REPORT NO: ST32-23R-63
WEPTASK NO: RAV09P003
PROBLEM NO: 27
DATE: 28 Jun 1963

NATC REPORT OF TEST RESULTS

Flight Test and Evaluation of ASTEK Instrument Corporation Large
Numeral Drum-Pointer Altimeters, Type A0009 20101 and Type B0001
22107; Final Report

FIGURE 3

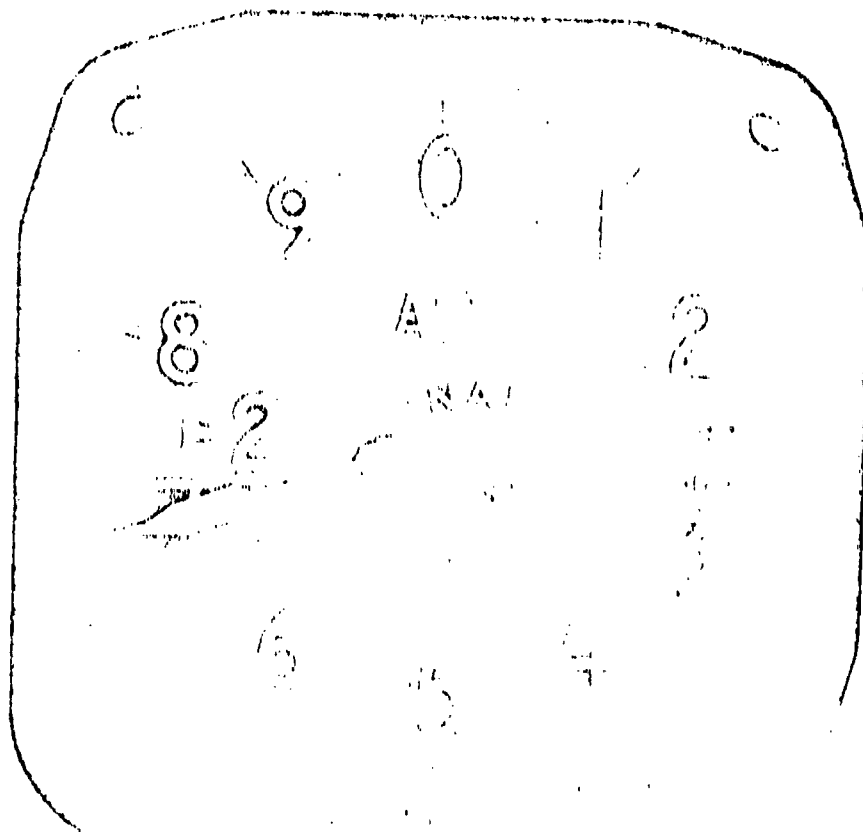
a. Readability (size and clarity of pointer and numerals) was satisfactory; however, the pointer hand partially obscured the one-thousand- and ten-thousand-foot digits when positioned within the 650- to 800-ft range as shown in enclosure (1), figure 3.

FIGURE 4

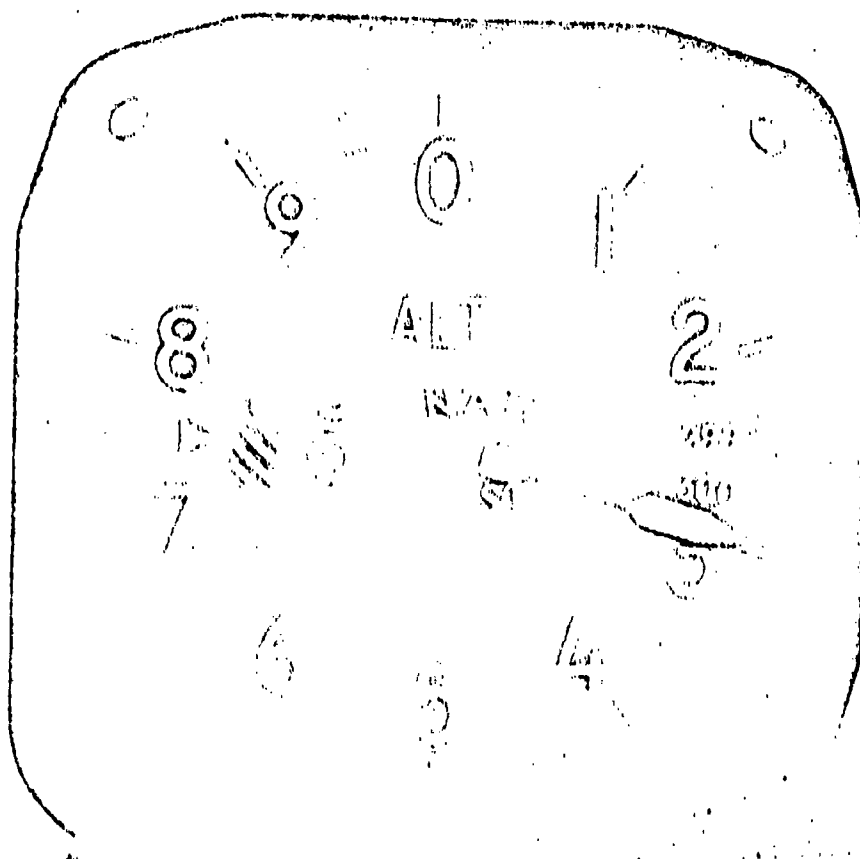
b. Interpretability of the altimeters was unsatisfactory; reading errors of one thousand feet and ten thousand feet were frequent. Portions of as many as four digits were visible on the numeral drum at some altitudes (enclosure (1), figure 4) making interpretation difficult and significantly increasing comprehension time. Movement of the thousand-foot drum, as a direct function of pointer displacement, facilitated the monitoring of altitude change and interpretation of indicated altitude. The drum feature was desirable, but the presentation of independently rotating digits for the multiple digit readout was unsatisfactory.
